NEW MEXICO OIL CONSERVATION COMMISSION

SUNDRY NOTICES AND REPORTS ON WELLS
(DO NOT USE THIS FORM FOR PROPOSALS TO DRILL OR TO DEEPEN OR PLUG BACK TO A DIFFERENT RESERVOIR. USE "APPLICATION FOR PERMIT -" (FORM C-101) FOR SUCH PROPOSALS.)

Manana Gas, Inc. - Cook # 1-E

Deviation Needed to Drill to an Orthodox Location

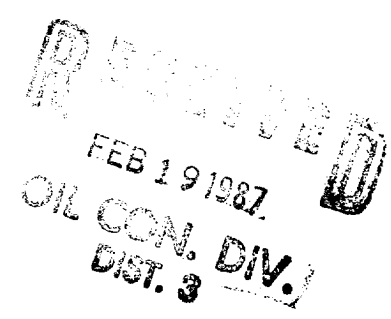
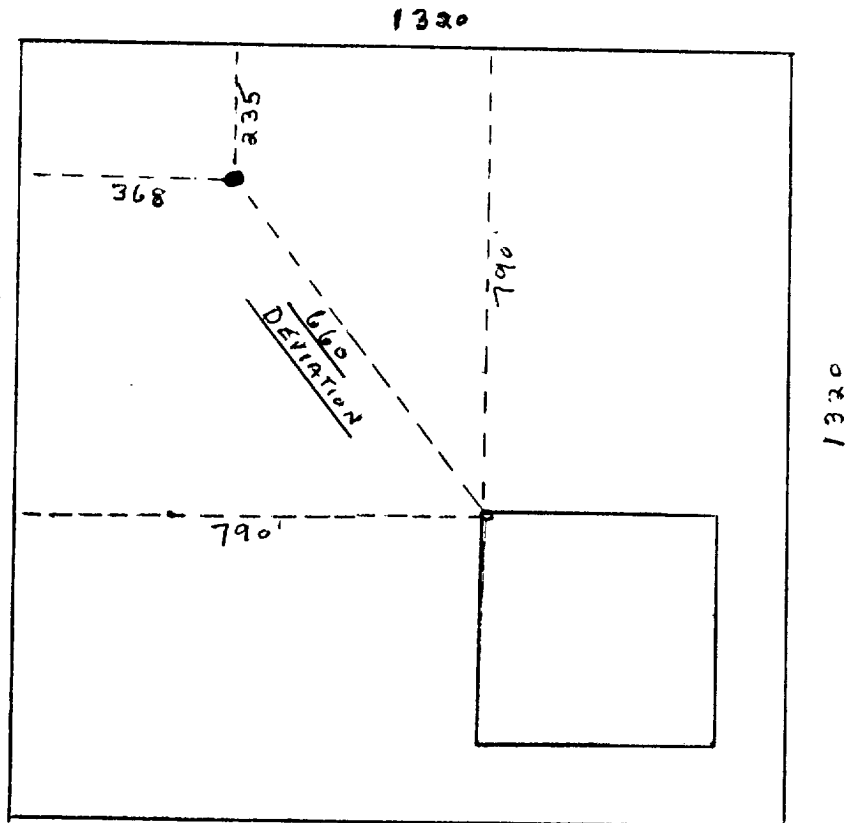
Due to objections raised by an offset operator this well will be drilled with a sub-surface deviation to the southeast so that the bottom of the hole will be at a standard location of 790 FNL and 790 FWL of Section 22-29N-11W.

All offset operators will be notified of this change in bottom hole location.
Deviation plat attached.

$$\frac{660}{6500} = 10.15\% \text{ DEVIATION}$$

SAY 700' DEVIATION

CONDITIONS OF APPROVAL, IF ANY:
Apply for permission per Rule 111 (c)(d)(e)

Hold for
Deviation Order
~~Application~~
